## SERVICE BULLETIN

ENGINE - AIR - REVISED HPT ACC MANIFOLD SUPPORT BRACKET - CATEGORY CODE 8 -  
MOD.ENG-75-0026

V2500-ENG-75-0026

Sheets) Modification of 2A1450 and 2A0202 Turbine Cooling Manifold  
Fig.1 (Sheet 1 of 3

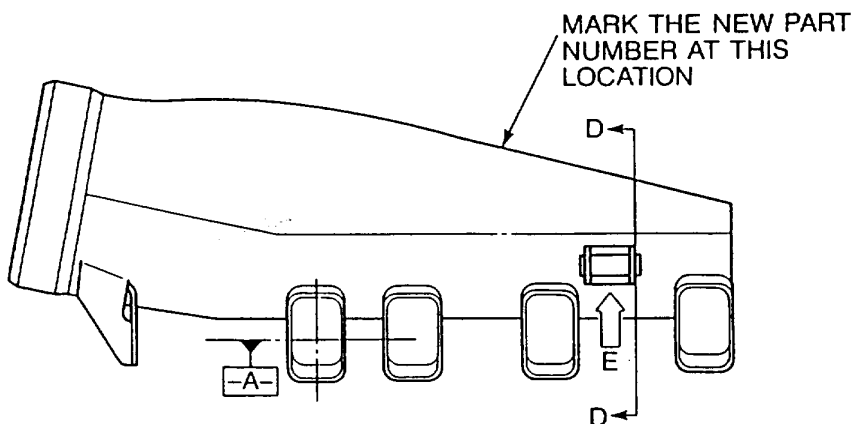
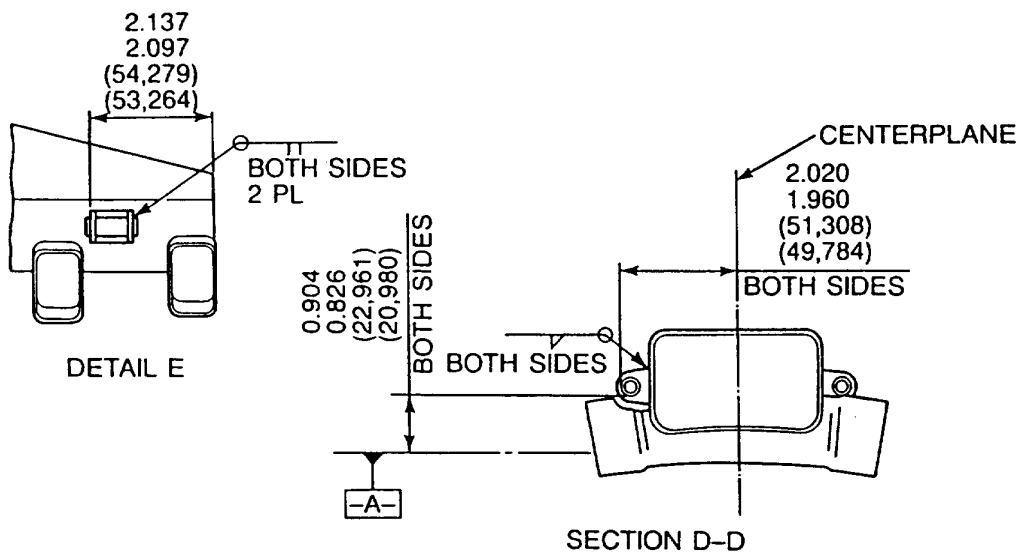
New Pin and Support are provided to increase strength of the side support pin of Turbine Cooling Manifold. New Support has an increased thickness and a full circular shape joint instead of existing a semicircular shape. Also new Pin has an increased length. Jointing of the pin and support is improved by the aforesaid changes.

- (1) The changes introduced by this Service Bulletin are as follows:
- (a) 2A1569 Turbine Cooling Manifold supercedes 2A1540 Turbine Cooling Manifold and 2A3665 Turbine Colling Manifold supercedes 2A0202 Turbine Cooling Manifold. Following composing parts of the Turbine Cooling Manifold are changed.
    - (i) 2A1564 Hollow Pin supercedes 2A0241 Hollow Pin.
    - (ii) 2A1563 TCC Manifold Support supercedes 2A0238 TCC Manifold Support.
  - (2) 2A1540 Turbine Cooling Manifold can be modified and re-identified to 2A1569 Turbine Cooling Manifold.
  - (3) 2A0202 Turbine Cooling Manifold can be modified and re-identified to 2A3665 Turbine Cooling Manifold.

Procedure	Supplementary Information
(a) Cut out the support at 2 points, each point is as close as the manifold	Refer to Figure 1 requirements Use a wire cutter

(b) Remove the residual support from the manifold body, keeping the original thickness of the manifold body	Use a hand held pneumatic grinder Refer to Figure 1 requirements

(d) Weld the Pin to the Support by tungsten inert gas (TIG) weld	Refer to Reference (2), 70-31-02 Argonarc Welding Repairs-01 and -08, and Figure 1 requirements. Use a tungsten inert gas (TIG) system. Use CoMat 03-204 welding filler wire.

(e) Weld the Support to the manifold by tungsten inert gas (TIG) weld	Refer to Reference (2), 70-31-02 Argonarc Welding Repairs-01 and -08, and Figure 1 requirements. Use a tungsten inert gas (TIG) system. Use CoMat 03-204 welding filler wire.

NOTE : MARK NEW PART NUMBER NEAR BY  
OLD PART NUMBER PER SPM TASK 70-09-00
